ElectraNet SA Capital Expenditure Review

Prepared for
Australian Competition and Consumer Commission

Prepared by
Meritec Pty Limited
Level 7, 140 Queen Street
Melbourne, VIC 3000
GPO 2260, Melbourne VIC 3001Australia
208410401

**A review of ElectraNet SA's proposed capital expenditure
for the period Jan 2003 to June 2008**

Figure 1 - Cumulative Probabilistic Capital Expenditure (\$2001/02)

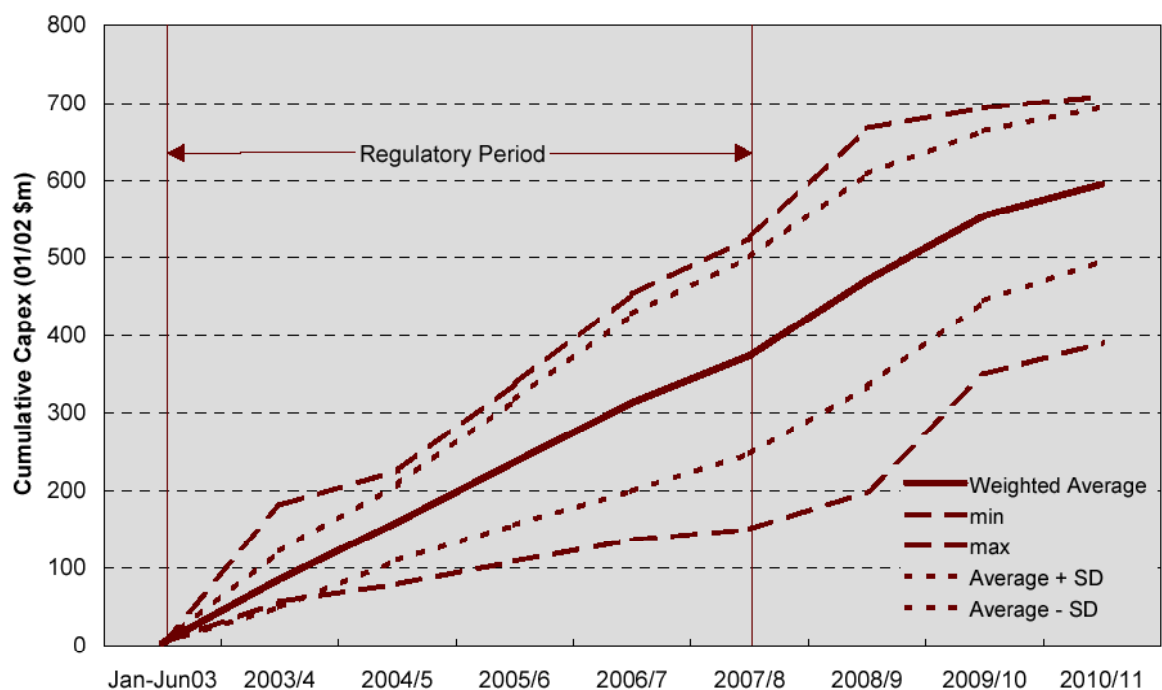
It can be seen from Figure 1 that there is a wide variation possible in the capital expenditure which can be expected depending on which scenario eventuates. Therefore,

However, if large variations from the expected level are experienced, it may be less easy to recover these by clawback. For instance, ElectraNet's figure for the most likely expenditure over the regulatory period is \$374 million (\$2001/02). If the actual expenditure was one standard deviation (by ElectraNet's figures) below this level it would result in an expenditure of only \$250 million (\$2001/02). The resulting \$120 million would need to be clawed back at approximately \$25 million per annum, possibly in the context of ongoing capital expenditure of approximately \$80 million per annum. This would have significant cashflows effects on the business concerned.

Conversely, if expenditure was to be one standard deviation above the predicted level, then this would equate to expenditure of \$500 million (\$2001/02). This equates to additional expenditure of \$126 million. This would potentially be rolled into the asset base at the next regulatory reset, however it could result in a large step change in charges.

Figure 2 - Transformer Age Profile

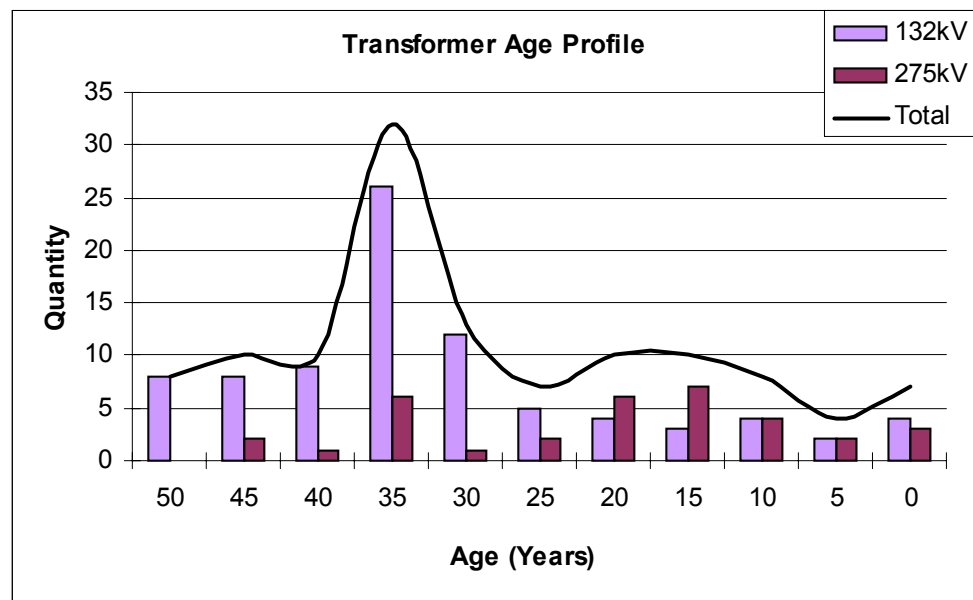
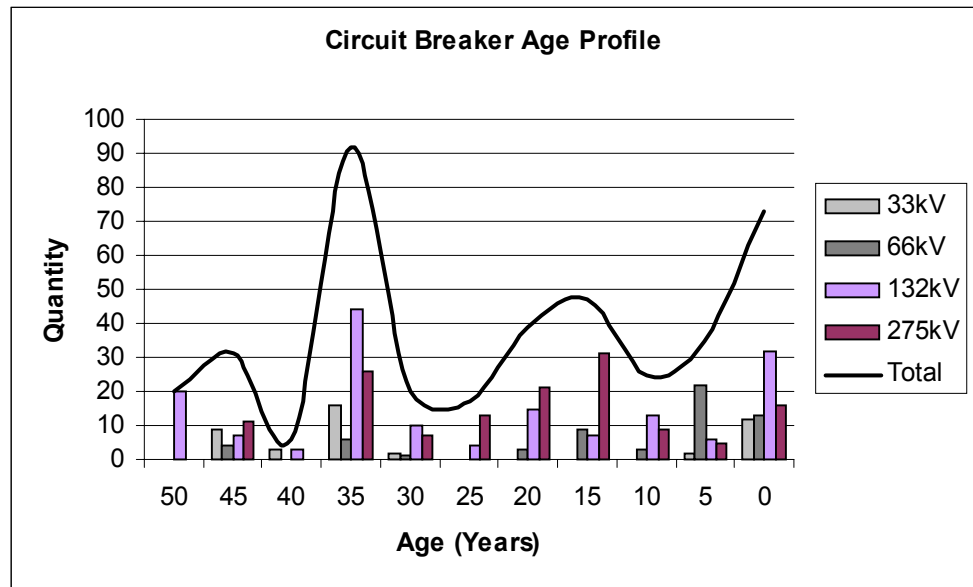
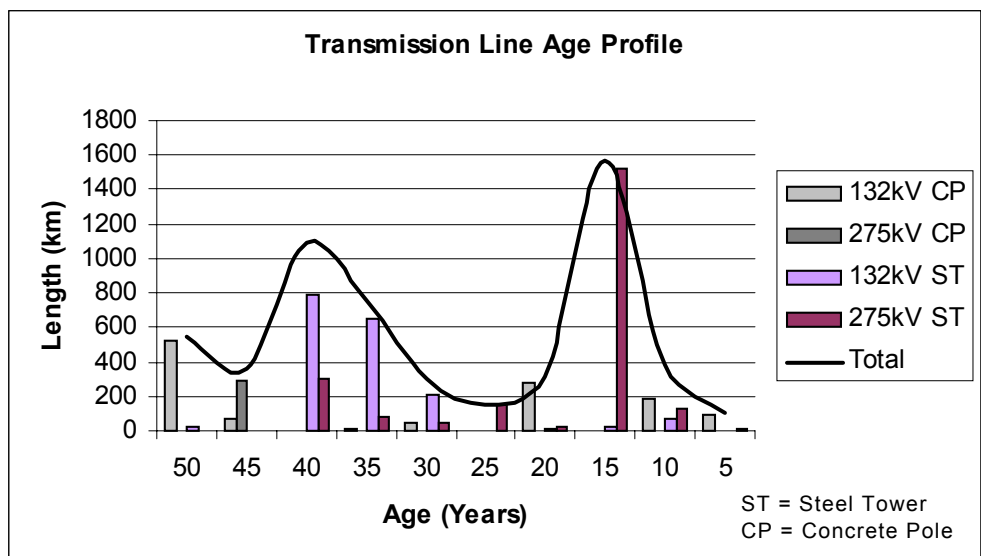
The above figures indicate that ElectraNet has 50% of its transformers aged 35 years or greater. For circuit breakers the figure is 37% and for transmission lines 50%. These

ElectraNet states in its Asset Management Plan for 2003-2008 that it has "set a target to reduce the percentage of assets > 40 years to 10% or less over the next ten years" (Section 6.2.7 p17). This strategy is aimed at progressively removing older assets from service and thereby avoiding a sudden step change in expenditure when these assets simultaneously reach the end of their service lives.
